Department of Transportation

MEMORANDUM

SUBJECT: ZC Case No. 21-12 – 850 South Capitol Street SE (Square 695-CSX West)

Figure 1 | Site Plan

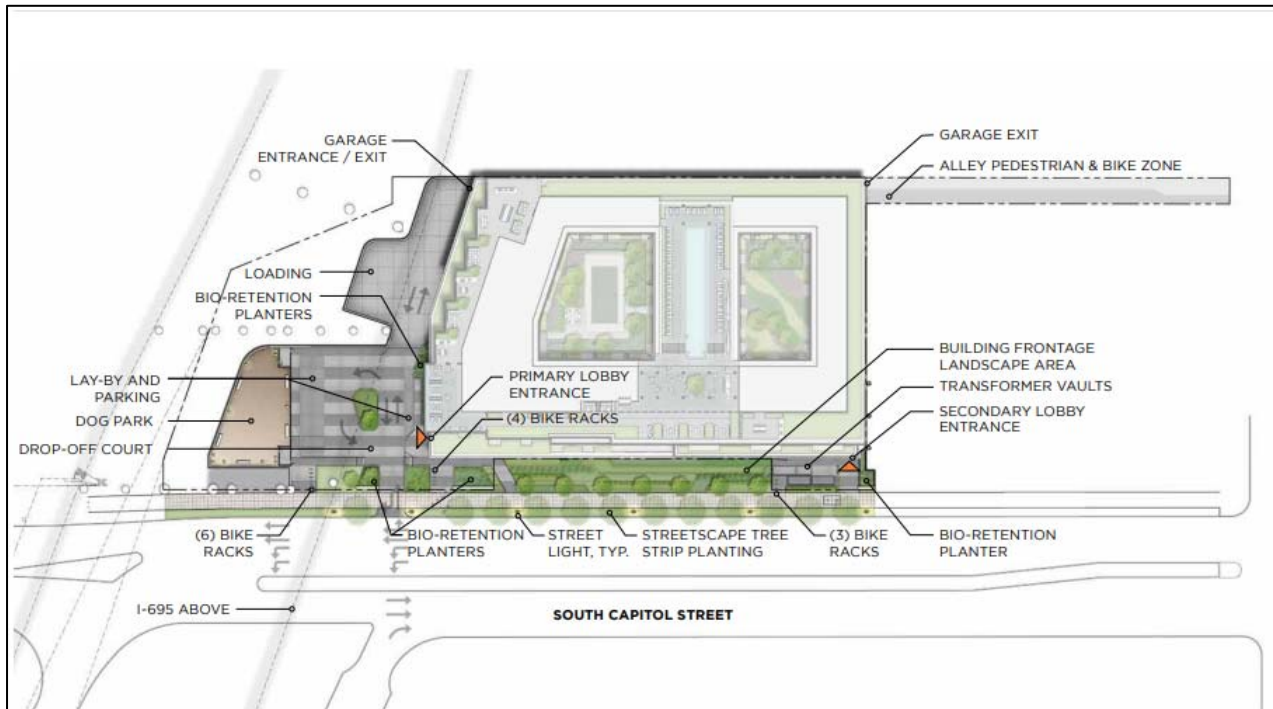
platforms. It is noted that part of the loading truck turnaround is located under the Interstate. If this is ultimately permitted under the Interstate, the Applicant should take measures to ensure that the bridge piers are not at risk of damage by trucks and other vehicles.

While the preliminary public space plans, shown above in Figure 1, are generally consistent with DDOT standards, there are several considerations that need to be reviewed in greater detail during the public space permitting process:

- The Applicant will negotiate a public access easement or other agreement with DDOT for shared use of the driveway to I “Eye” Street SE.
- Coordinate with DDOT regarding the design of the area under the Interstate. Minimize the amount of construction near bridge piers and ensure DDOT has access to maintain the bridge;

- Ensure the curb cut does not impact the existing I-695 overpass and ramps or the South Capitol Street Corridor project;
- Review the need for a mountable curb on the southern side of the S. Capitol Street curb cut to accommodate 40-foot trucks;

- Ensure compliance with the South Capitol Street Corridor project's public space guidelines, which require a 19 feet 4 inch sidewalk area and 15-foot setback on the east side of South Capitol Street. Coordinate the streetscape design with the neighboring property to the south;

- As part of streetscape review, Applicant must include streetscape designs before and after South Capitol Street is reconstructed;
- There is a 24-foot wide, 214-foot long, strip of land owned by the District and not included in the ZC application along South Capitol Street that is shown as green space. This is a critical strip of land in the future streetscape of the South Capitol Streetscape project;

- Ensure that the proposed dog park elements, curbs, and other improvements under the I-695 overpass are setback 15 feet from the bridge piers and associated infrastructure and allow access for DDOT maintenance vehicles on short notice;

- Remove all permanent elements, such as the dog park fencing, underneath the I-695 overpass;
- Identify final locations in public space for the short-term bicycle racks; and

- Identify a location on public or private property for a Capital Bikeshare concrete pad and 19-dock station. A typical 19-dock station with kiosk is 53 feet wide by 6 feet deep.

Figure 4 | Existing Pedestrian Network

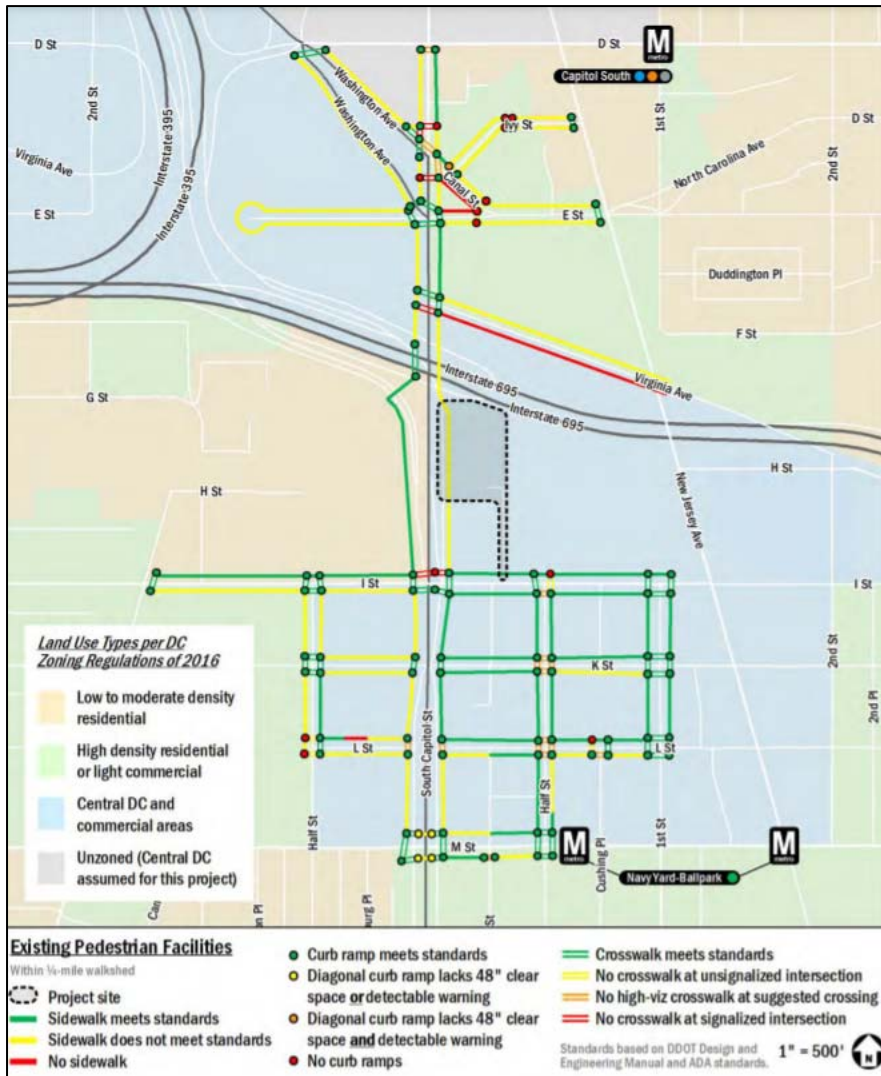
The Applicant’s inventory of existing pedestrian infrastructure, as shown in Figure 4 below, demonstrates that most sidewalks in the immediate vicinity of the site are currently constructed with appropriate widths and include accessible curb ramps. While there are a number of missing or substandard facilities in the broader area, the existing pedestrian network along major walking routes from the site to schools, attractions, and the Metrorail station is generally adequate.

As part of this development, the streetscape along S. Capitol Street will be upgraded to DDOT standards. To increase the safety of the pedestrian network, the Applicant proposes a separated pedestrian pathway along the private driveway connecting the development to Eye Street SE. This pathway will allow for easier access to many of the site’s walking destinations to the east and south. As the Applicant goes through public space permitting, they should coordinate with DDOT on how to best delineate the pedestrian/bicycle area from the vehicle travel lane (i.e., alternate paving, signage, striping).
